**CITY OF BOULDER
PLANNING BOARD MEETING AGENDA**

- A. **AGENDA TITLE:** Concept Plan Review and Comment on a proposed redevelopment at 1050, 1004, 990, 986, and 976 Arapahoe Ave. for permanently affordable senior housing. The existing Presbyterian Manor building at 1050 Arapahoe Ave. would remain. The project would involve combining four existing lots with the larger parcel and constructing a new 60-unit, three-story structure. Reviewed under case no. LUR2026-00001.
- B. **AGENDA TITLE:** Public Hearing and consideration of a Site Review for a Height Modification only for a detached dwelling unit located at 1039 Mapleton Ave. The height modification is necessary to add habitable space above the by-right height and to document the changing low point due to a proposed building expansion. No other modifications are proposed. Reviewed under case no. LUR2024-00028.

AGENDA TITLE: Concept Plan Review and Comment on a proposed redevelopment at 1050, 1004, 990, 986, and 976 Arapahoe Ave. for permanently affordable senior housing. The existing Presbyterian Manor building at 1050 Arapahoe Ave. would remain. The project would involve combining four existing lots with the larger parcel and c

Figure 3: Conceptual Site Plan

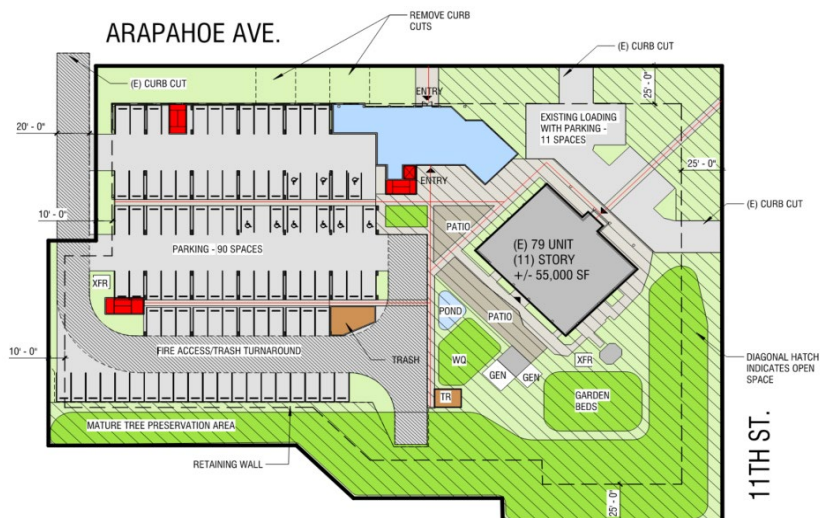
The proposed location of parking along most of the ground floor adjacent to Arapahoe Avenue is contrary to the goals for parking to be subordinate to site and building design and to not impact the public realm. While parking will not be an exposed surface parking lot, the façade screening will lack the activity and vibrancy that should contribute to the pedestrian realm. It is assumed the window openings would not be glazed to provide for natural ventilation of the parking area, which increases the visibility and impacts of parking in this location.

entrance at the eastern end of the site, leaving the remaining length without access and reinforcing the inactive parking use behind. The existing four houses along Arapahoe Avenue currently provide active uses, multiple entries, and visual permeability between them into the site that meaningfully contributes to a comfortable pedestrian experience. Alternatively, a revised design should consider other active non-residential uses with multiple entrances on the ground floor facing Arapahoe Avenue.

The design placing structured parking directly along the street frontage is not successful and should be revised. Review and reduce the areas devoted to parking to improve the efficiency of the design and minimize the amount of pavement necessary to meet parking needs, in particular the provision of structured parking along the street frontage and reduce the amount of pavement devoted to emergency/trash turnaround areas.

The design of the proposed parking areas, which includes both (existing) surface and ground level parking along the street frontage, should be revised so that the proposal will improve upon the character of the area and promote a vibrant pedestrian experience along Arapahoe Avenue.

If a new structure is proposed along Arapahoe Avenue in place of the existing four small houses, revise the programming and design of the ground level along the street to minimize parking adjacent to Arapahoe Avenue and provide an appropriate ground floor use. Staff is generally not supportive of "faux" architectural features in lieu of authentic building and window designs providing transparency and activity at the ground level.
